# 3C PL1 – 324 Cherry Street

Schematic Design 2

April 22<sup>nd</sup>, 2020

Review Stage: Schematic Design 2

# Landscape | Adjacent Future Revitalization

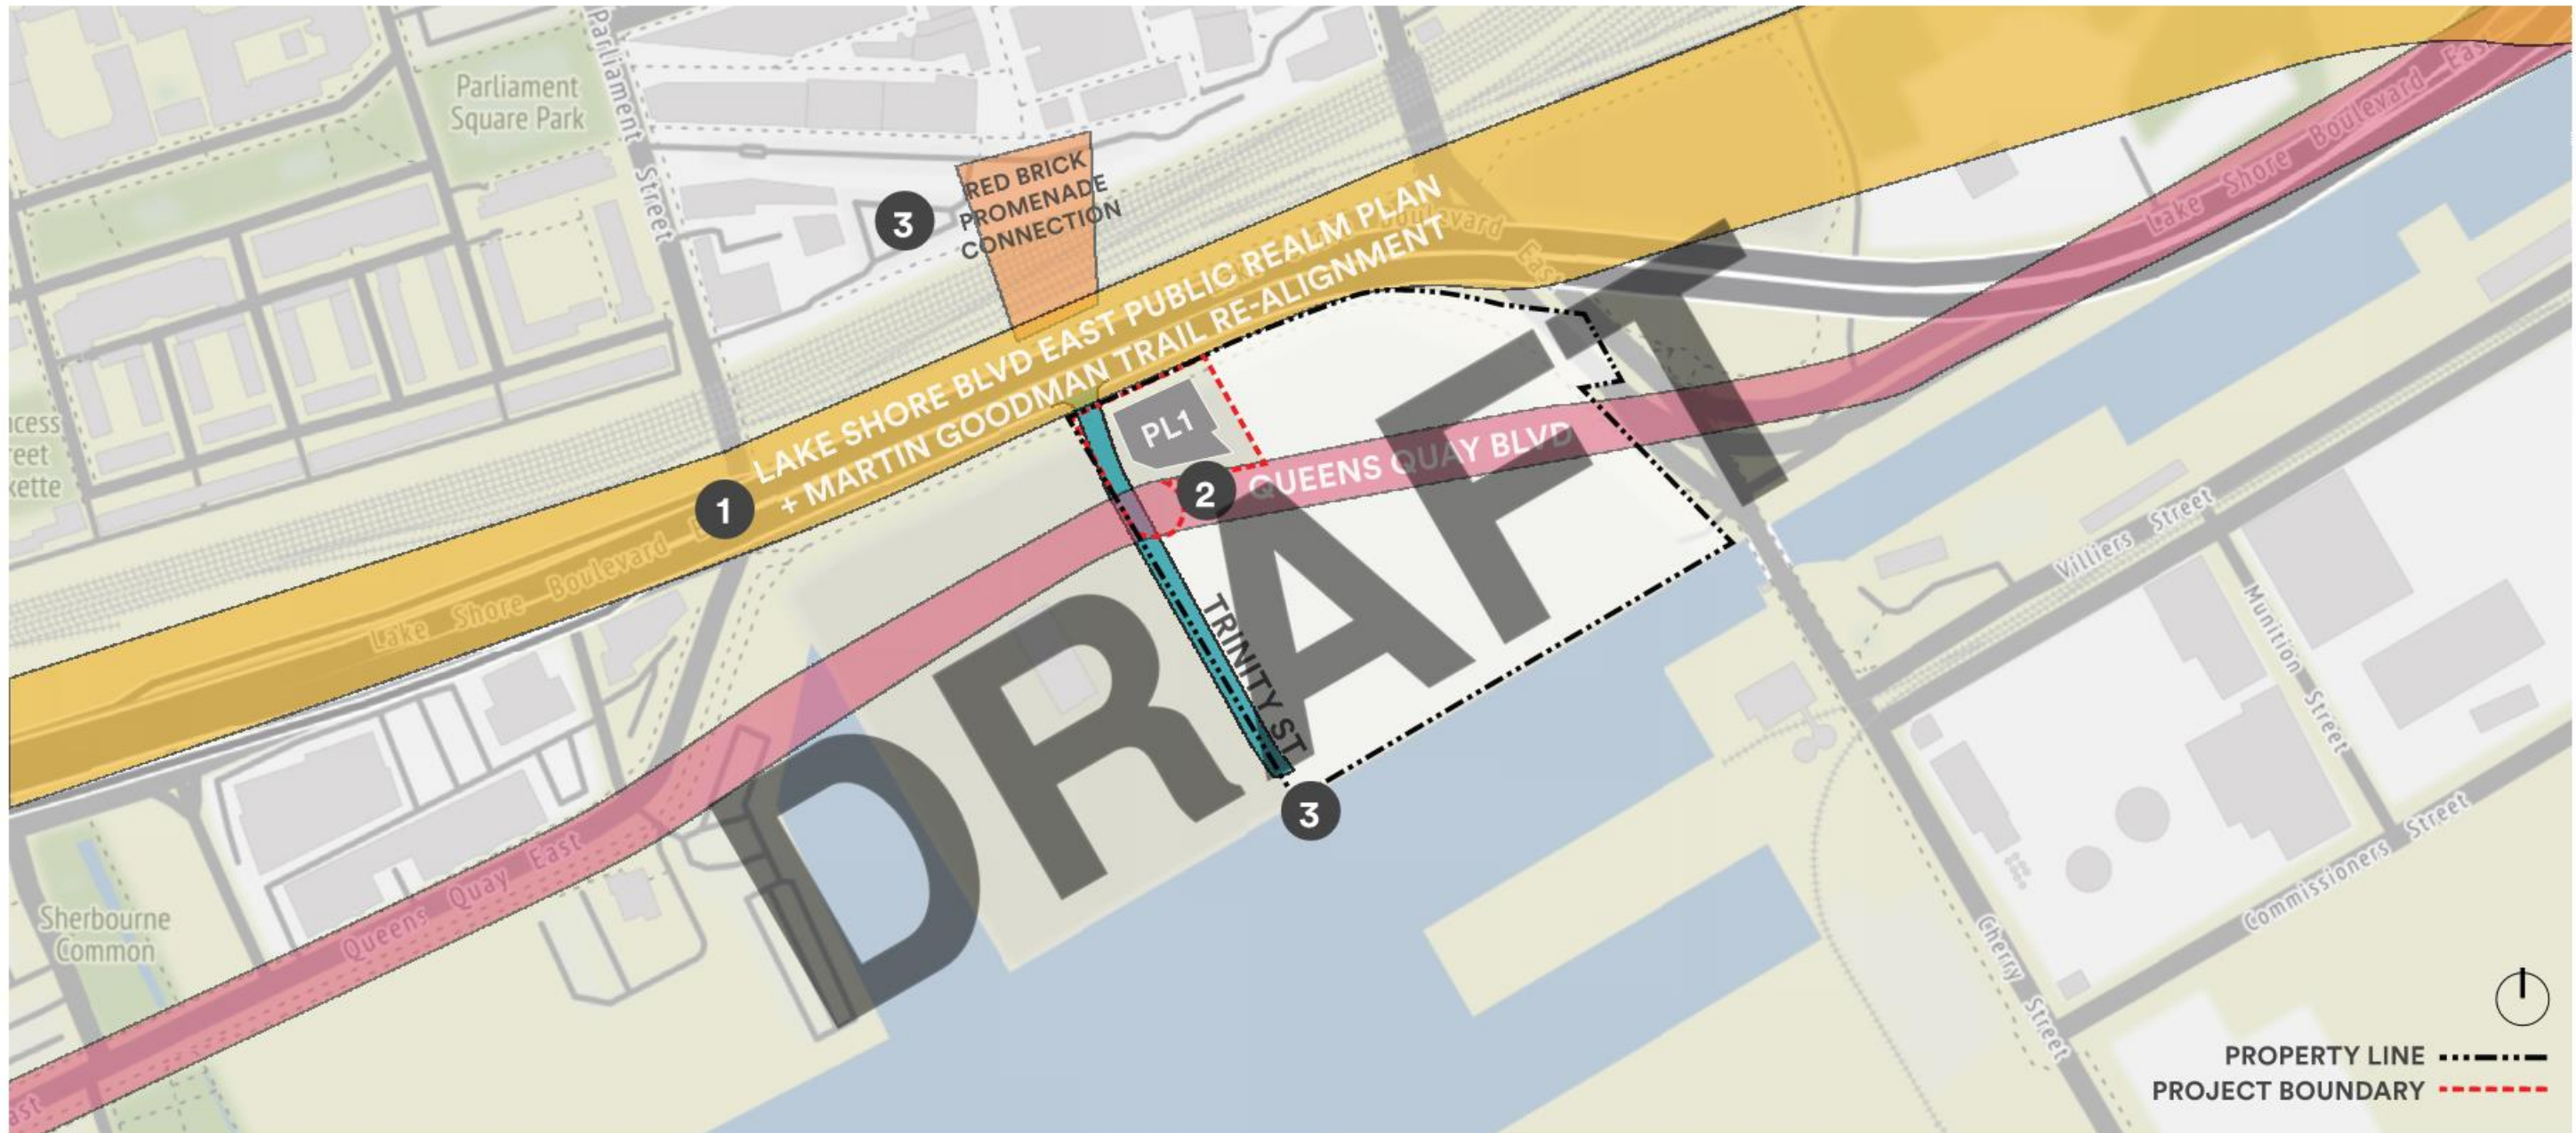
5. Think ahead and consider how the temporary Phase 1 landscape will connect with future Phase 2 development; Incorporate the final streetscape of Queens Quay and Lake Shore Boulevard into the landscape design to anticipate future connection.

**Response:** Landscape design has protected for future public realm investments i.e. Lake Shore Blvd., Queen Quay and Trinity Street.
